Attachment 2

**Southern Environmental Law Center | The Wilderness Society
MountainTrue | Defenders of Wildlife | The Sierra Club**

March 22, 2022

**Notice of Objection to the Revised Land Management Plan
for the Nantahala and Pisgah National Forests**

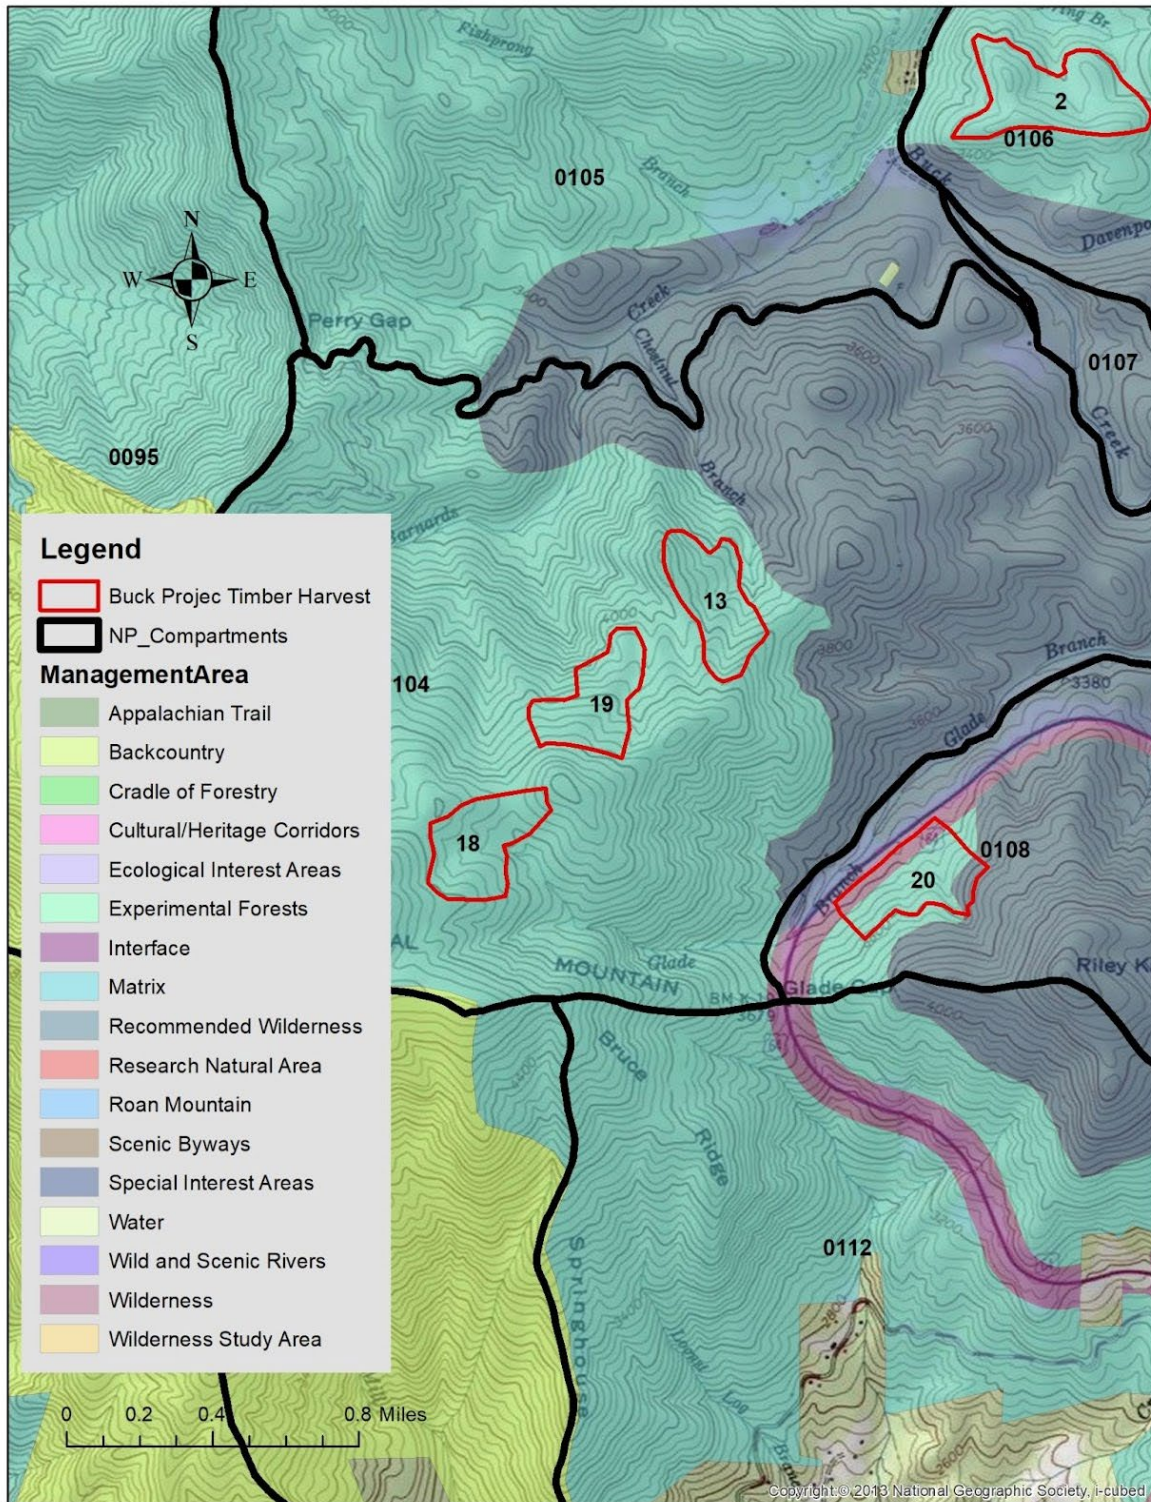
This is not a hollow exercise. For example, the Final Environmental Assessment for the Southside Project prescribes two-aged regeneration harvest for stand 41-53. The justification for this treatment is “vegetation habitat improvement, and for forest regeneration, sustainability, and provision of early successional habitat.” Southside EA at 10. Alternative E allocates stand 41-53 to the Special Interest Management Area which only allows timber management to “[i]mprove threatened, endangered, or SCC habitat, “[r]estore, enhance, or maintain rare plant communities,” “[r]estore, enhance, or mimic historic fire regimes,” “[r]educe insect and disease hazards,” or “[p]rovide for public safety.” SIA-S-02, Plan at 226. The agency must explain how two-aged regeneration harvest in this stand is consistent with the revised plan or omit this treatment from the Southside Project.

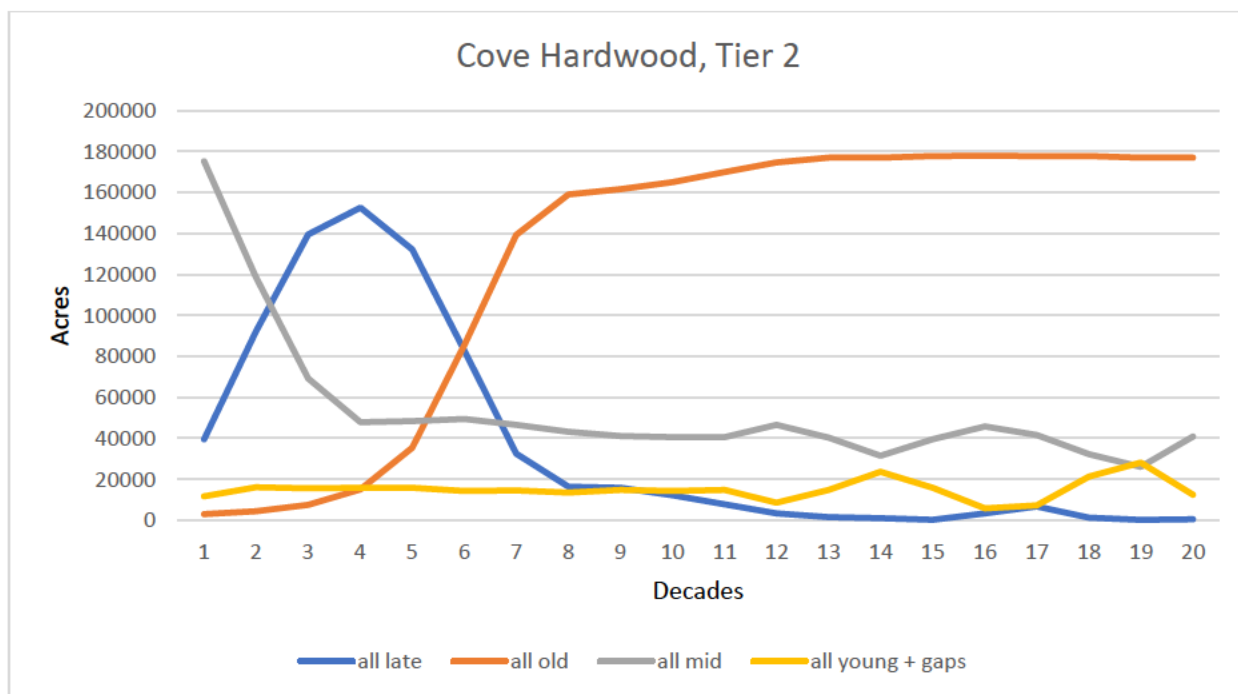
At the same time, young forests and old forests are shown as being *over* NRV levels. Cove forests illustrate the problem well.

In this graph, a large bolus of mid-age forests (currently 60–100 years old) transitions into late-age forests (in periods 1 to 4) and then into old forest (in periods 4 to 8). Meanwhile, late-age forests decrease to essentially zero.

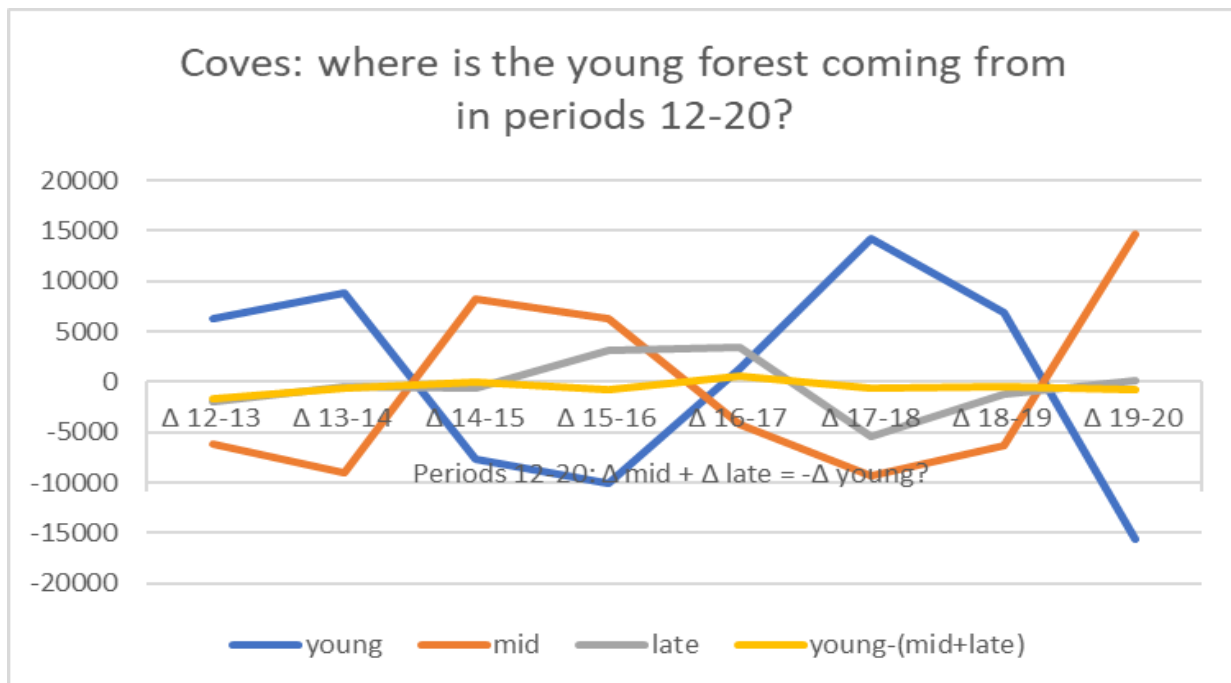
Comparing movement among young forest and mid-/late-aged forest levels shows that the Forests are relying on constant harvest of mid- and late-aged forests to meet young forest goals, with almost no turnover taking place in old forests. This is easy to see during periods 12 to 20, after the old forest class has stabilized. During those later periods, the change in the amount of young forest in each period is almost perfectly offset by the change in the amount of late and old forests. (Note: where the yellow line is at zero, 100% of early forest is coming from mid- and late-age forests.)

Rather than small-gap turnover in the old forests—the dominant driver for disturbance in this ecozone under NRV—the Spectrum model predicts large-patch young forest creation primarily in in mid-age forests. The Spectrum model is producing these results because it has been asked to hit targets for young forest derived by a model using a different set of assumptions about how natural disturbance operates on the forest. Without the substantial turnover in the old forest the NRV model predicts, effectively all of the unavailable forests become old and stay old. Spectrum (unlike the NRV model) includes vanishingly little age-resetting natural disturbance, especially in mesic systems. Indeed, Spectrum models only about 40 acres per year of natural disturbance for Alternative E’s Tier 2 in all moist forests *combined*.

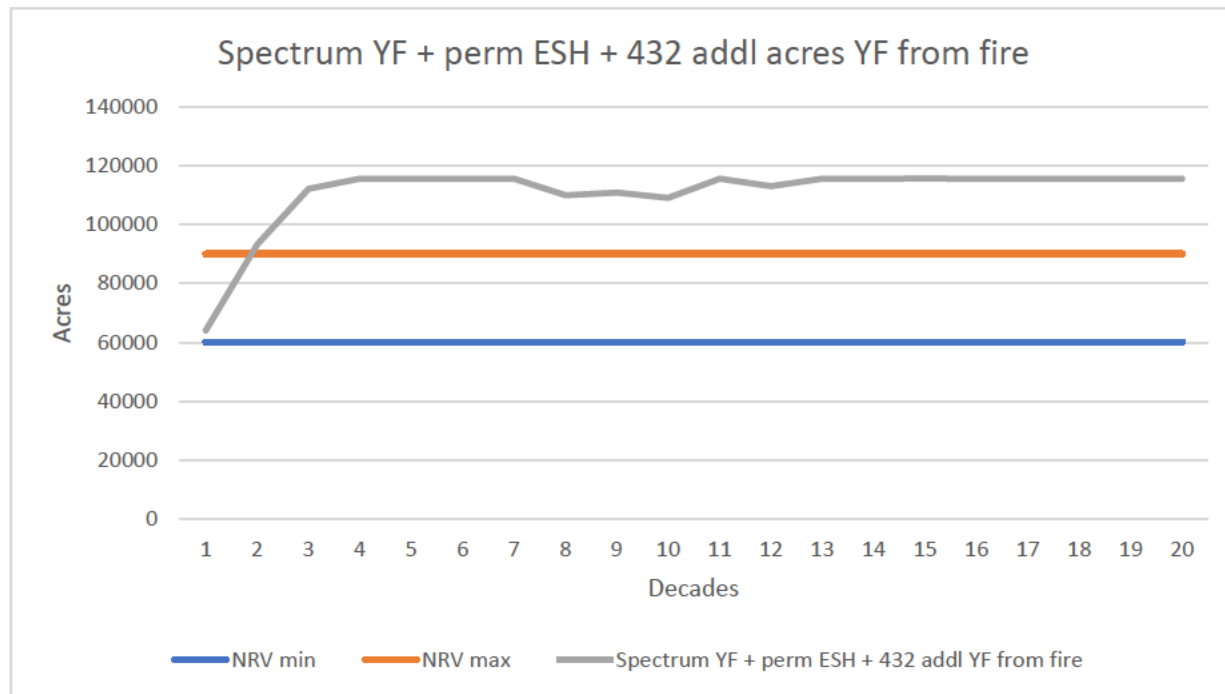
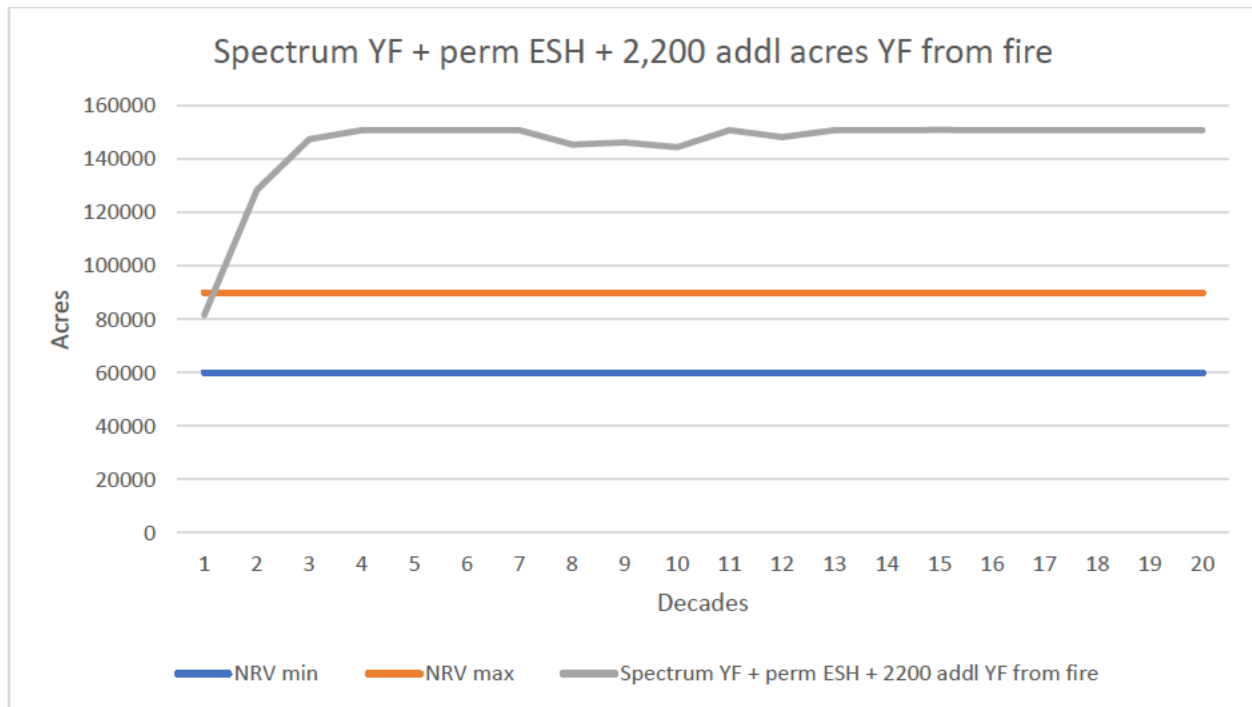
As shown in the two graphs below, adding even conservative effects of repeated fire, plus the permanent ESH discussed above, to Tier 2 levels of regeneration harvest will take the forest landscape even further outside the NRV for young forest.

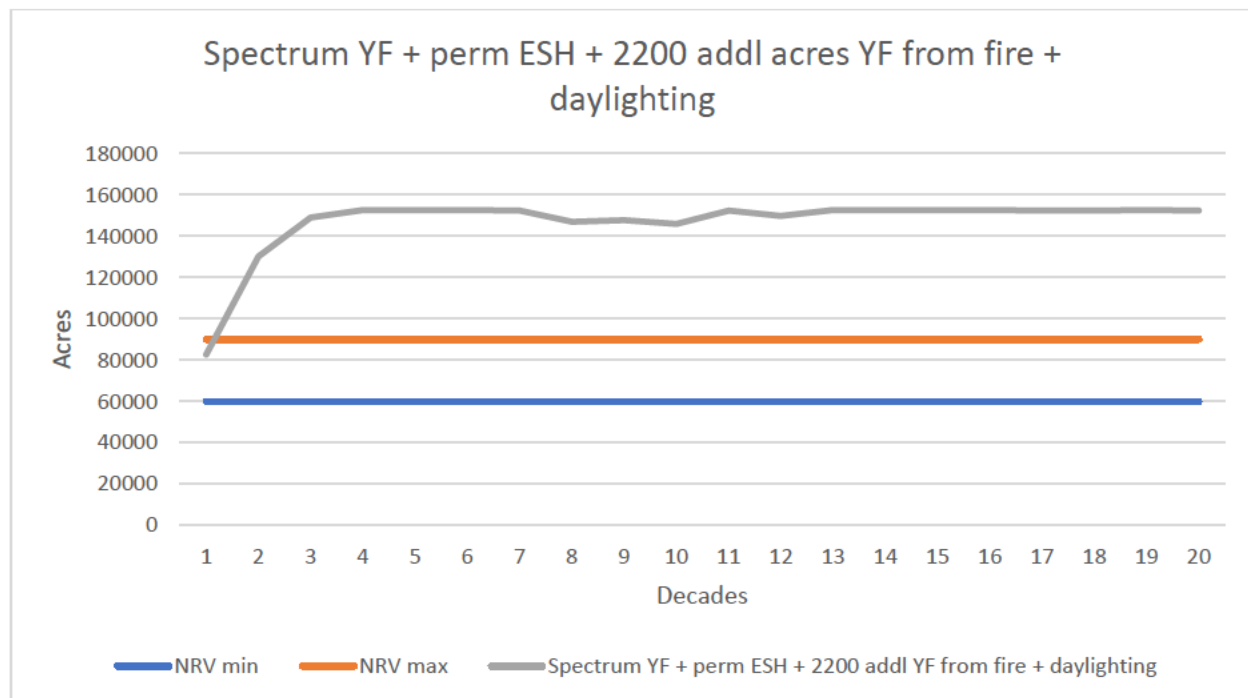
In addition, Spectrum fails to model the effects of daylighting to create ESH. We raised this issue in our DEIS comments, but it was not addressed in the FEIS. DEIS Comments at 32–33. The Plan sets an objective to daylight two miles of road per year at Tier 1 and five miles of road per year at Tier 2, for the express purpose of creating ESH.

Assuming that daylighting creates ESH up to 80 feet away from the road (the radius of a 1/2-acre circle), 5 miles of this activity would create 100 acres annually of ESH, or 1,000 acres per decade. If half the acres persist in ESH condition for 10 years (mesic forests) and half persist for 20 years (dry forests), then this would create an additional 1,500 acres of ESH that the Forests have not accounted for anywhere, as shown in the following graph along with the cumulative effects of the previously discussed errors.

Max Patch Open Area Acreage

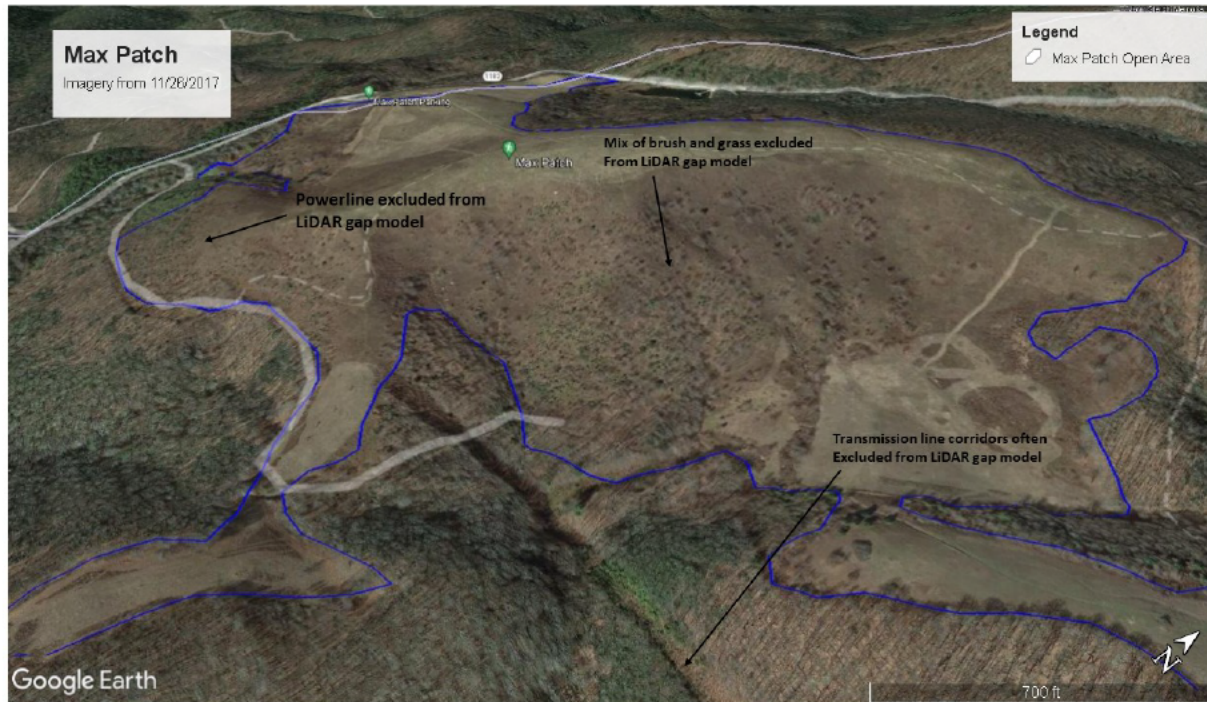
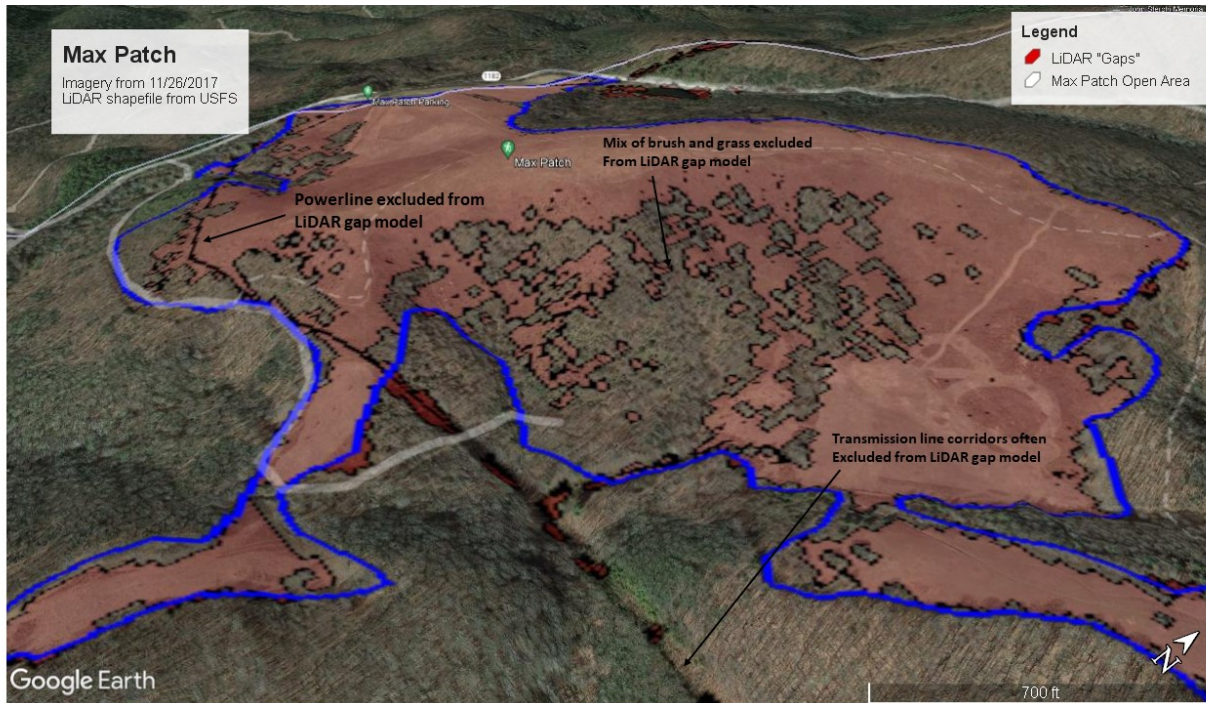
Last, we note that the LiDAR parameters are especially poorly suited for detecting young forest created by fire. When fires kill trees, the dead trees are often left standing. LiDAR has no way of distinguishing live trees from dead trees; it thus misses many gaps and patches created by fire. One example of this is from the Rock Knob Fire (2016) in Southern Nantahala Wilderness. Aerial imagery from 2017 clearly shows at least 16 acres of forest completely charred by wildfire, but the LiDAR gap model detected gaps totaling less than an acre, and no patches larger than 0.5 acres that would contribute to the Forests' estimates of "young forest."
